**Sport Plus Mode**

Revision: **This bulletin replaces bulletin Group 9, #35/14, dated December 10, 2014.**  
 > Under "Restriction:" **NOT** approved for Diesel models! was added.  
 > Work procedures were revised.

Model Year: **As of 2015 up to 2016**

Concern: **Retrofitting**

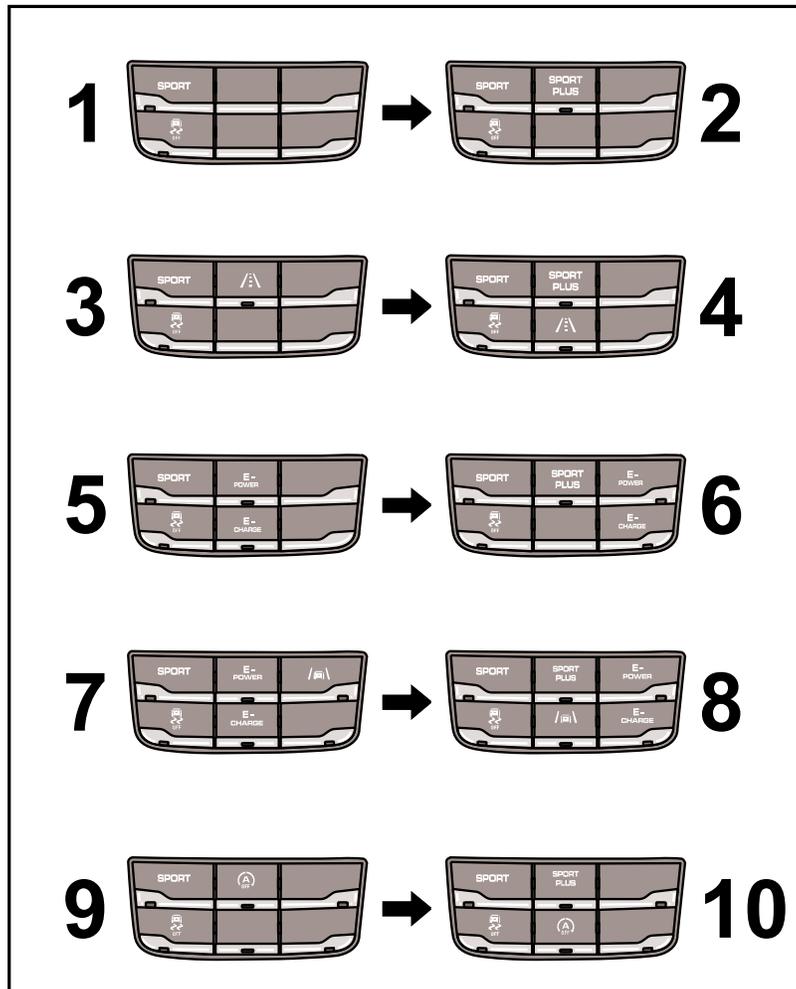
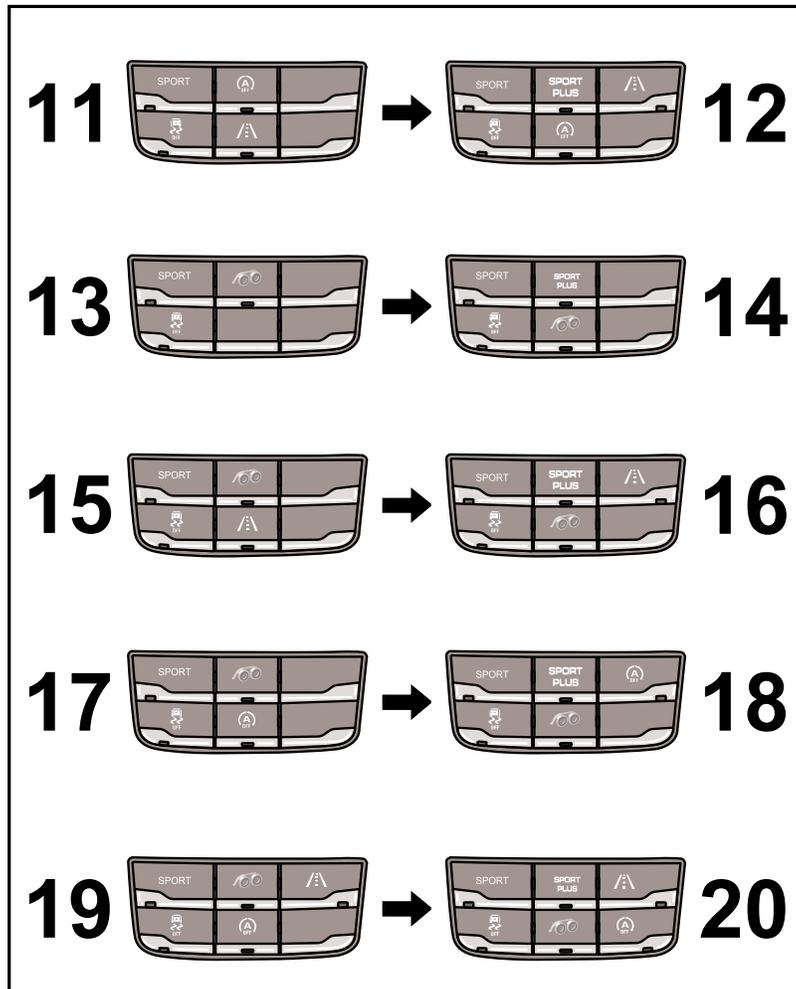
Information on ordering: A strip for switches (keypad) must also be ordered.  
The following illustrations and table make ordering easier.

Figure 5

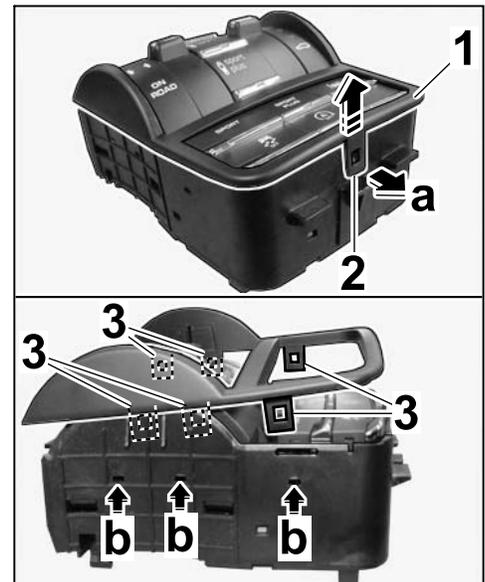
- 2.1 Release locking lug – at the front (⇒ *Figure 5 -a-*) and lift the trim up slightly (⇒ *Figure 5*).

Insert a small screwdriver into the housing (⇒ *Figure 5 -b-*) and **carefully** release the clips (⇒ *Figure 5*).

Pull the trim up and off.

Figure 6

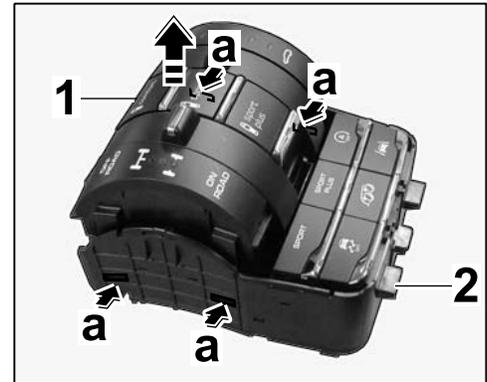
2.2 Release combined switch (⇒ *Figure 6 -a-*) and pull it out of the keypad (⇒ *Figure 6*).

2.3 Insert combined switch into the new keypad and press it down until the combined switch locks with an audible click.
